JP Research Summary: JASIC Flex Injury Estimate

GTR09 PH2 Informal Working Group

17 Sept 2012

Figure 2. Impact Speed Distribution

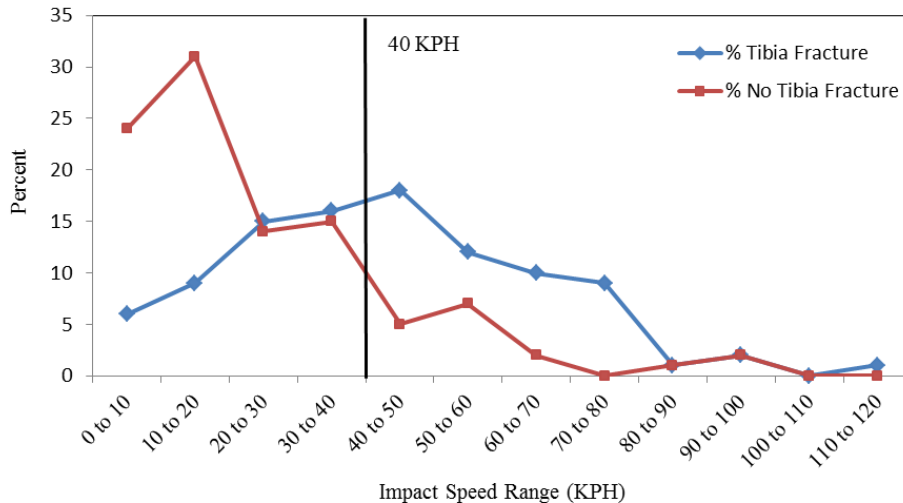
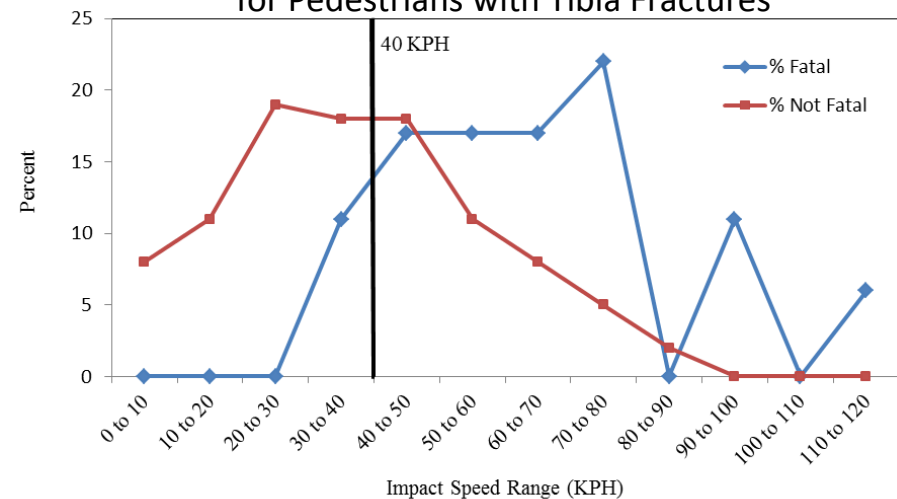
- Impact speed is an important contributor to injury severity for pedestrians interacting with motor vehicles.
- The PCDS data was used to identify the distribution of impact speeds for pedestrians with and without tibia fractures
 - Figure 2: 53% of the pedestrians with tibia fractures were associated with high impact speeds (>40KPH) which implies there could be multiple injuries associated with those crashes
 - Figure 3: 90% of the fatal pedestrians with tibia fractures were involved in crashes with high impact speeds (>40KPH)
 - Both Figures 2 and 3 show the sampling variability due to the small sample of the PCDS data
 - Injury estimates cannot be reliably derived from this PCDS data to represent the injury experience of pedestrians with tibia fractures.

Figure 1a: PCDS - Injury Type by Body Region
(Pedestrians (ages 16+) with Tibia Fractures and Other MAIS 4+ Injuries)

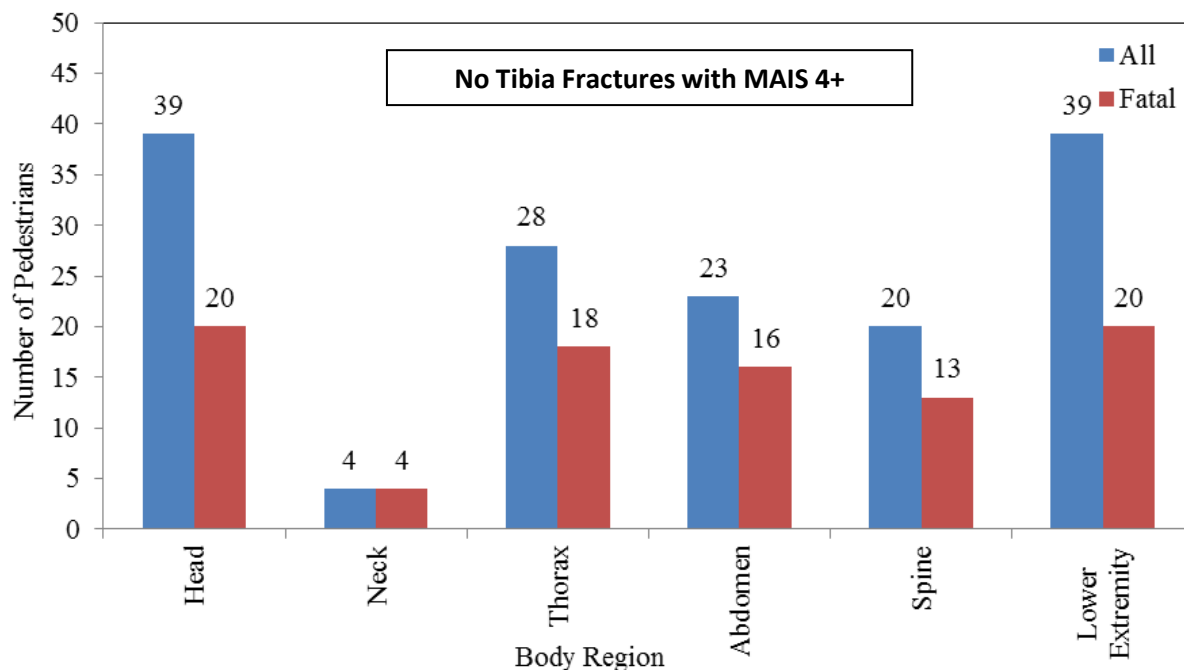
- Figure 1a shows that tibia fractures should not be examined in isolation because those with tibia fractures often suffered from other injuries
 - Of the 98 PCDS who suffered a tibia fracture for impacts less than or equal to 40 KPH, just 2 had only that injury
 - Using injuries from PCDS data to project for national estimate of tibia fracture fatalities will most likely overstate the tibia fracture caused fatalities
